CHAPEL HILL ADDITION TO WICHITA, SEDGWICK COUNTY, KANSAS

RE: S/D 9884 - Final Plat of CHAPEL HILL ADDITION

STAFF REPORT

CASE NUMBER: S/D 98-84 - CHAPEL HILL ADDITION

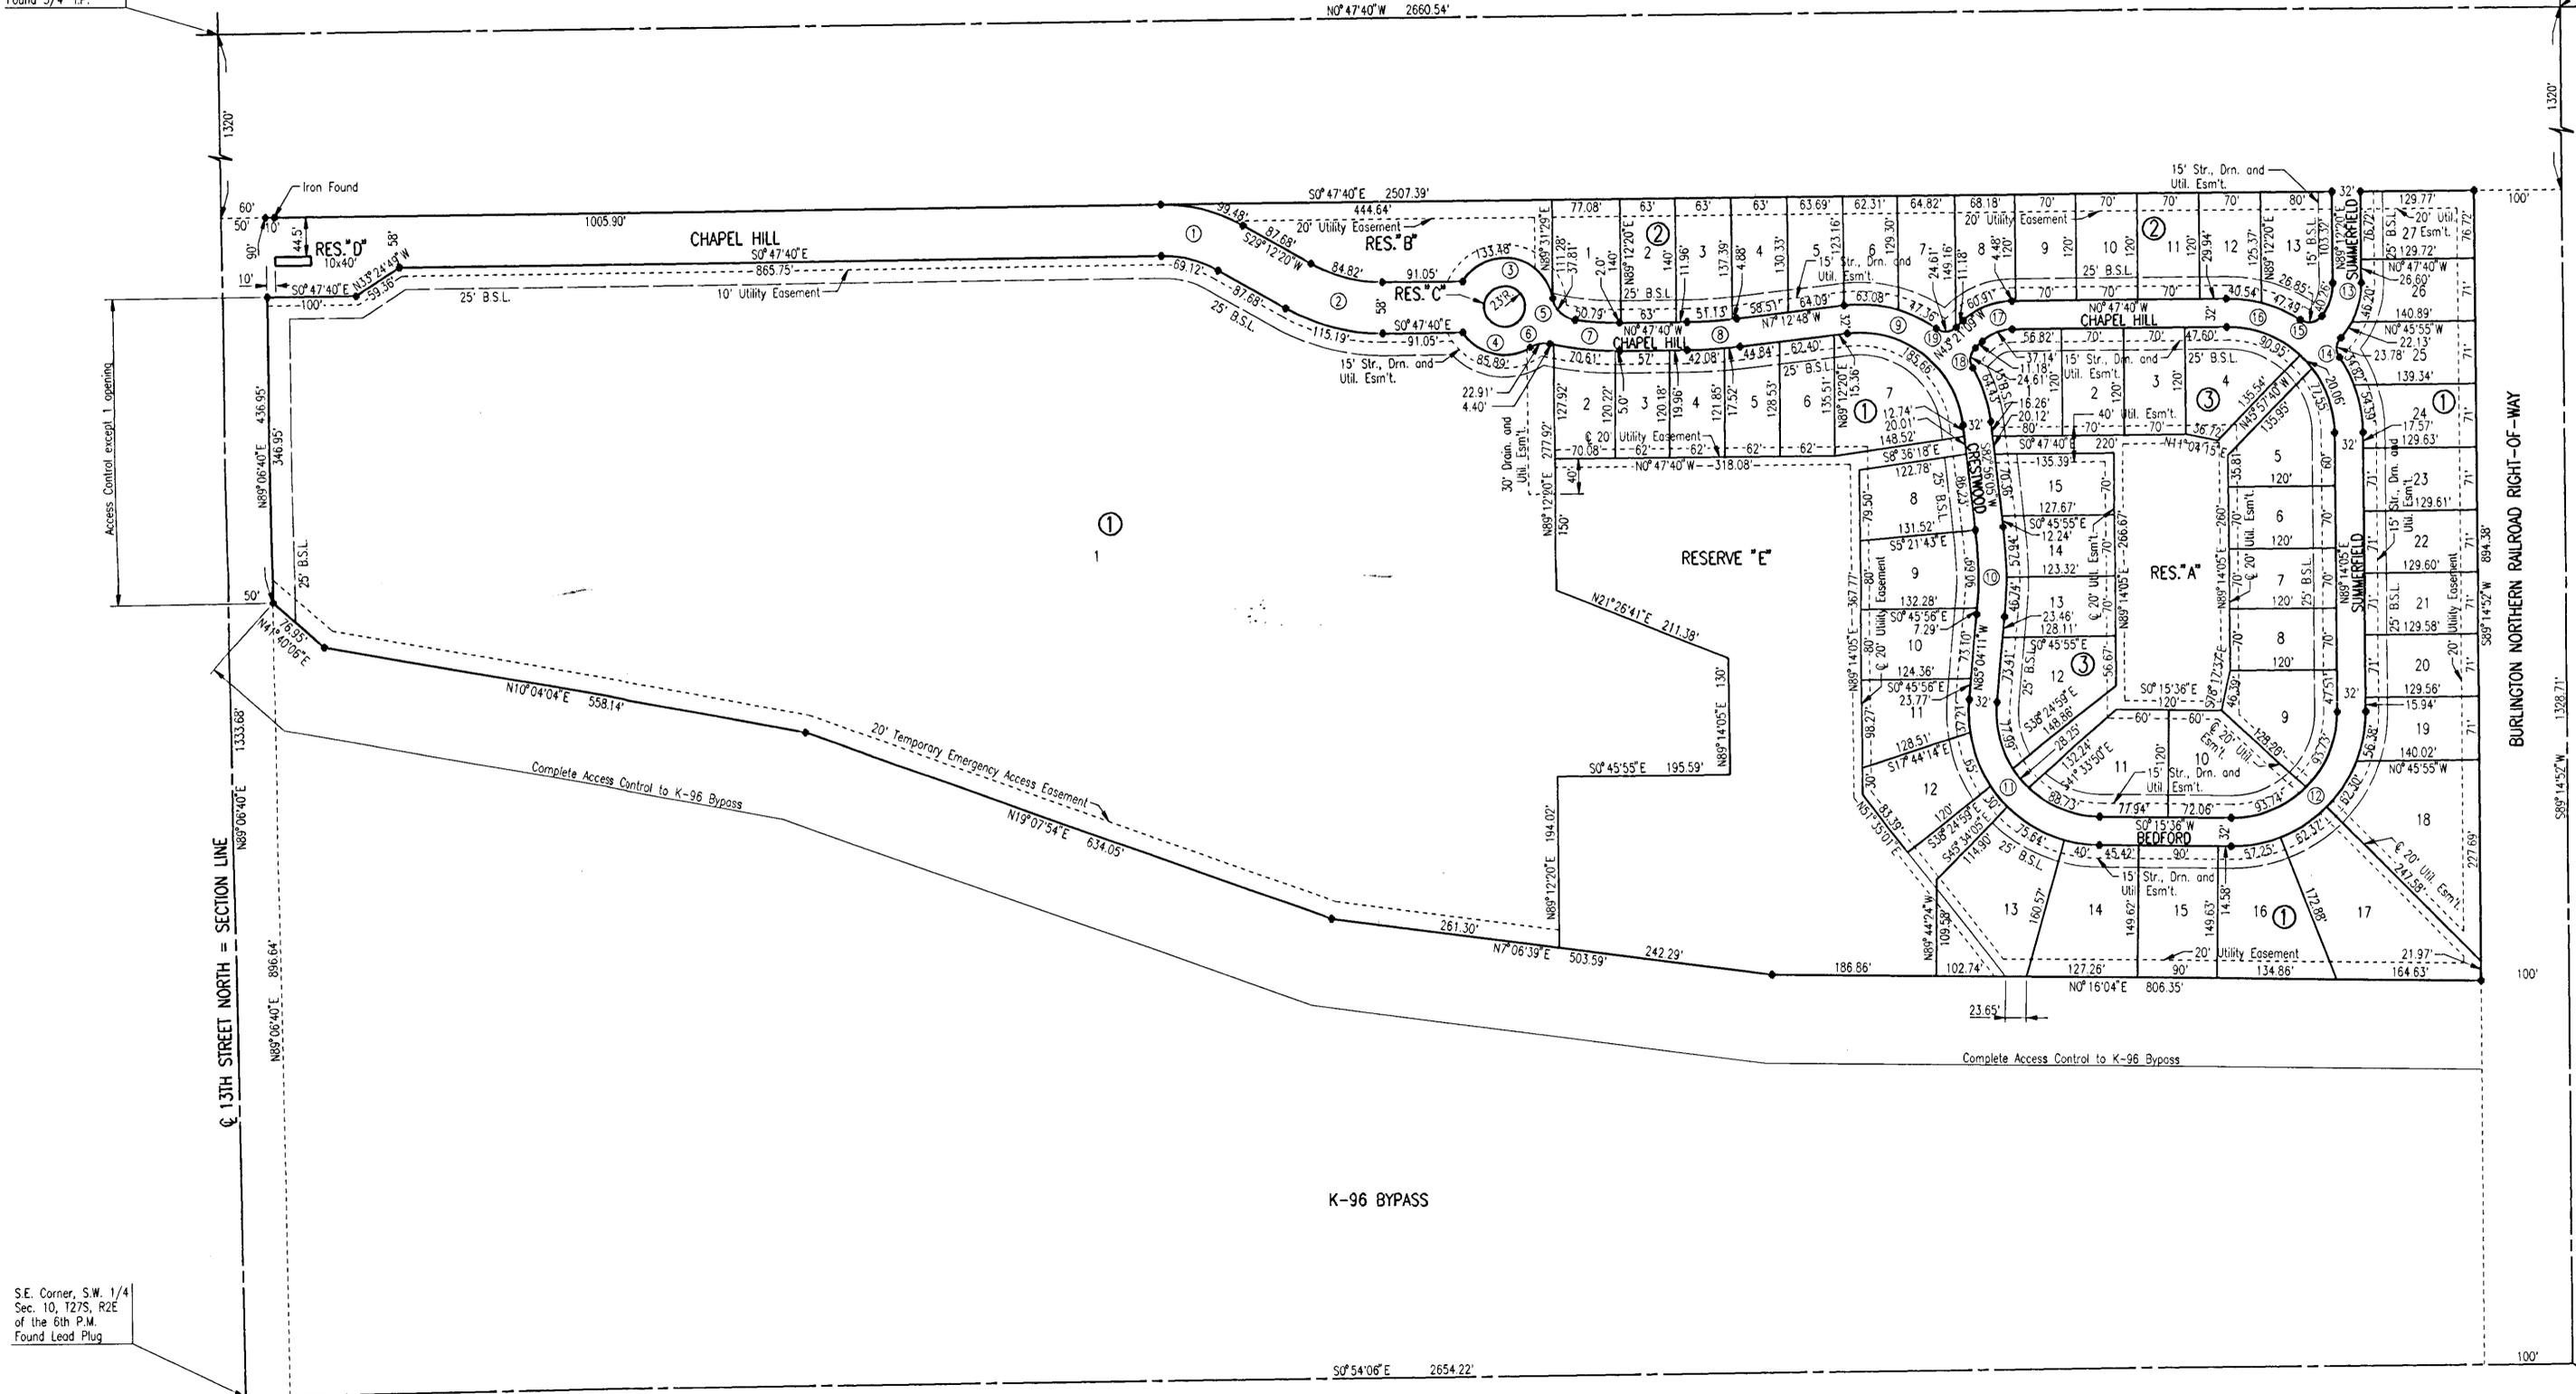
- A. This plat will be subject to approval of the associated zone change (SCZ-0767) and any related conditions of such a zone change.
- B. The applicant shall guarantee the extension of sanitary sewer to serve the lots being platted. This guarantee shall be with the County for service through the Four Mile Creek sanitary sewer system. On the final plat tracing, appropriate wording shall be added to the Mayor's signature block indicating the City's agreement to allow a County sewer district to be formed within the City. **A sanitary sewer layout plan shall be submitted to County Engineering.**

- E. **City Engineering** needs to comment on the status of the applicant's drainage concept and of any minimum building pad requirements as a result of a lake (Reserve E) being created. **A letter is needed from KDOT pertaining to their acceptance of drainage onto K-96. The drainage concept is approved. Minimum pad elevations need to be denoted for lots adjacent to the detention pond.**

- F. The plat denotes one access opening along 13th St. North. Traffic Engineering needs to comment on the need for complete access control on the east side of the frontage adjoining K-96. The plat's text on the final plat, shall note that access controls are being dedicated to the City of Wichita and that the location of the opening is subject to approval by the City Engineer. *Access controls are sufficient.*
- G. The distance to the northernmost lots is approximately 3,000 feet; in excess of the 600 foot maximum noted in the Subdivision Regulations for cul-de-sac access. Currently, the proposed street stub to the west does not have any connection and Fire Department needs to comment on a potential emergency access easement for a second point of access to this plat. *City Fire Department requires a second point of access. Applicant has agreed to include an emergency access easement.*

The final plat has included the requested emergency access easement; however it should be extended northward to connect with Crestwood Street.

- I. Since this plat proposes the platting of narrow street right-of-way with adjacent "15-foot street drainage and utility easements", a restrictive covenant shall be submitted which calls out restrictions for lot-owner use of these easements. Retaining walls and change of grade shall be prohibited within these easements as well as fences, earth berms and mass plantings.

- K. Traffic Engineering needs to comment on the need for improvements to 13th St. North. *No improvements are needed.*
- L. The applicant shall guarantee the paving of the proposed interior streets. For the narrow public 32-foot streets, this guarantee shall be for the 29-foot paving standard. This guarantee shall also provide for sidewalks along one side of the streets. *The Applicant has submitted an alternate sidewalk plan. The plan denotes a sidewalk around the perimeter of the park (Reserve A) with connections along*

- M. The applicant shall submit a covenant which provides for four (4) off-street parking spaces per dwelling unit on each lot which abuts a 32 or 58-foot street. The covenant shall inventory the affected lots by lot and block number and shall state that the covenant runs with the land and is binding on future owners and assigns.

The final plat has included the requested minimum building pad elevations. City Engineering needs to comment on the status of the applicant's drainage plan. *The drainage plan is approved. A drainage guarantee is required.*
